**Evaluation of South Texas Project Electric
Generating Station Units 1 And 2 Offsite Dose
Calculation Manual, Revision 6**

**Docket No. 50-498, Facility License No. NPF-76
Docket No. 50-499, Facility License No. NPF-80**

Technical Evaluation Report For The Evaluation Of South Texas Units 1 And 2 ODCM

Figure 1. STP liquid radwaste pathways.

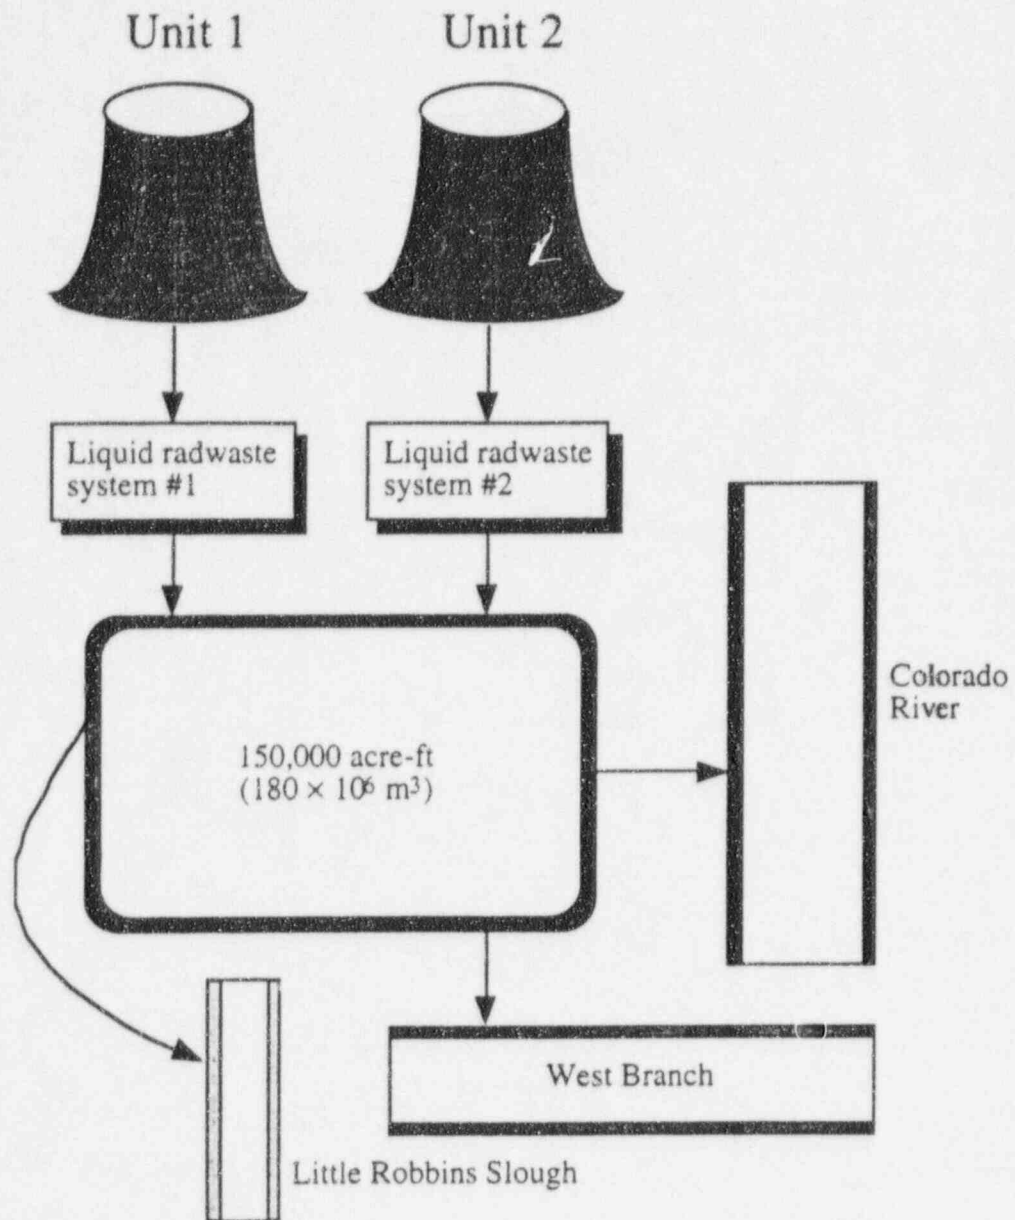
The STP ODCM does not contain any diagrams of the liquid effluent release points, flow paths, and alarm locations. One or more simple figures should be included that illustrate the liquid effluent pathways. Also, it is recommended that diagrams of the liquid radwaste effluent system and other relevant systems be included in the ODCM. Detector locations should be included in these figures. The form of the suggested figures is shown in Figure 1 although sufficient detail is not shown in this figure.

The STP ODCM contains two diagrams related to radioactive effluent treatment and release routes. Diagrams are included only for the gaseous effluent release points. It is recommended that graphical representations of the liquid effluent release points, paths and alarm locations be made. In addition, it is suggested that the gaseous effluent diagrams be revised as they are difficult to read, rely on unexplained abbreviations, and are not very detailed. The Branch Technical Position⁸ states that the ODCM should contain "simplified flow diagrams defining the treatment paths and the components of the radioactive liquid and gaseous waste management systems." The licensee should replace the present figures with appropriate simplified flow diagrams.

Figure 2. Primary gaseous effluent release routes at STP. (Based on Figure B2-1 of the STP ODCM Revision 8.)

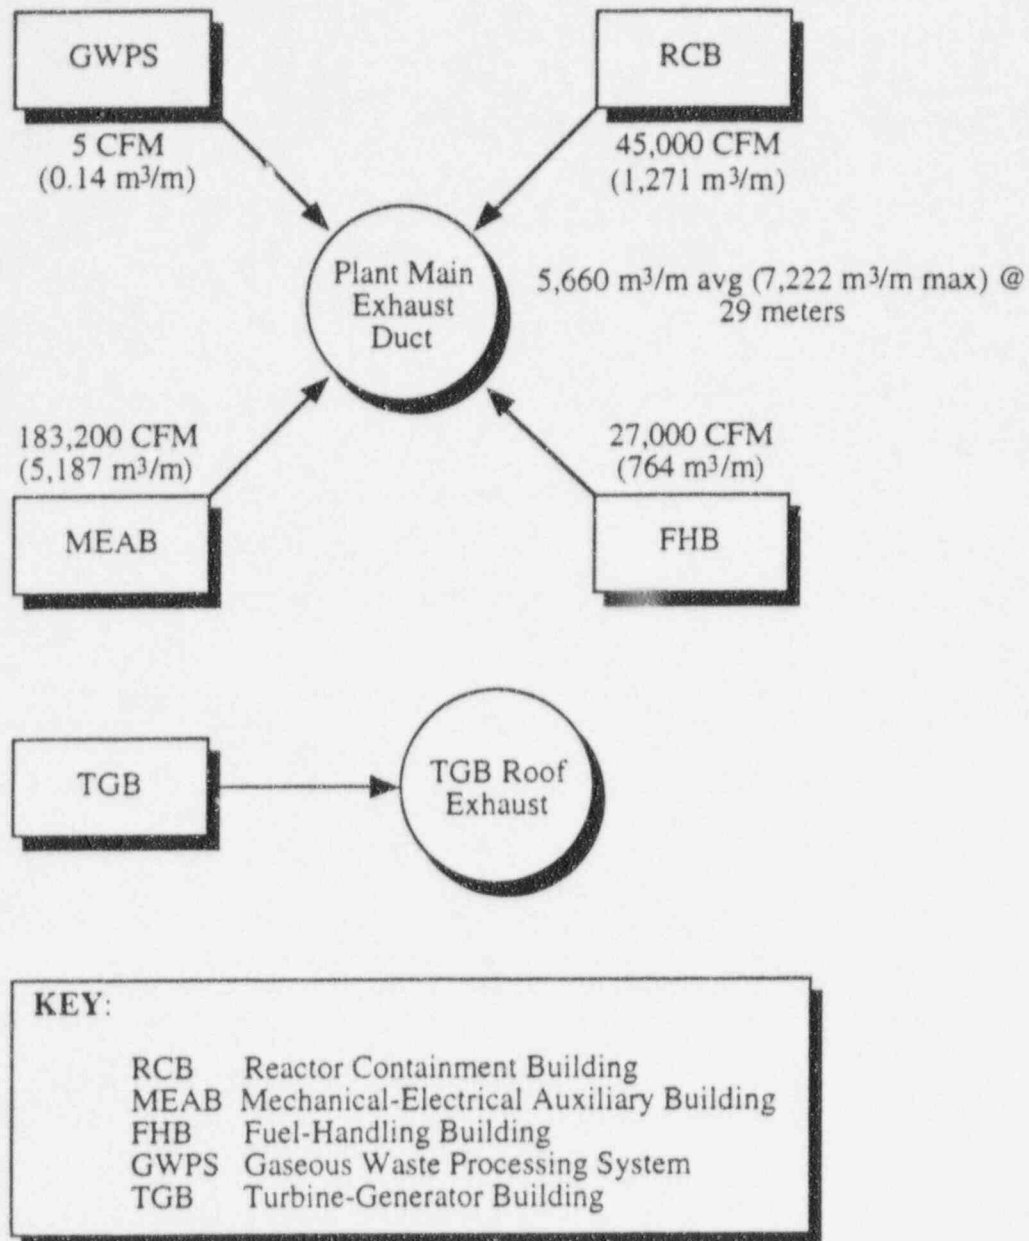
Only the first four sources contribute significantly to routine plant atmospheric releases. The effluents from the first four sources are routed to a common exhaust pipe located on the roof of each unit's MEAB. The Turbine-Generating Building has its own exhaust pipe located on its roof. Figure 2 illustrates the five radioactive gaseous discharge points, and Figure 3 illustrates the Turbine-Generator Building Exhaust. In Figure 2, the sum of the release rates is about 7,000 m³/min; however, in Section 2, it states that the average flow rate is 5,600 m³/min. Maximum flowrates for different operational modes should be defined in the ODCM.

In Table 3.3-13, a monitor for the vent is identified. The condenser evacuation system effluent, which was monitored, has been rerouted to the vent for one reactor and is in the process of being rerouted to the unit vent for the other reactor. It should be made clear in the ODCM that there is a unit vent monitor for each unit. Also, ODCM Figure B2-1, Unit Ventilation Systems, is missing the gaseous waste processing system and Turbine-Generation Building gaseous release pathways. This information should be included in one or more diagrams that illustrate the gaseous release pathways.

1. In Table 3.3-13, a monitor for each unit vent is identified; however, it should be made clear that there is a unit vent monitor for each unit. Also, ODCM Figure B2-1, unit ventilation systems, is missing the gaseous waste processing system and Turbine-Generation Building gaseous release paths. This information should be included in one or more diagrams that illustrate the gaseous release paths.
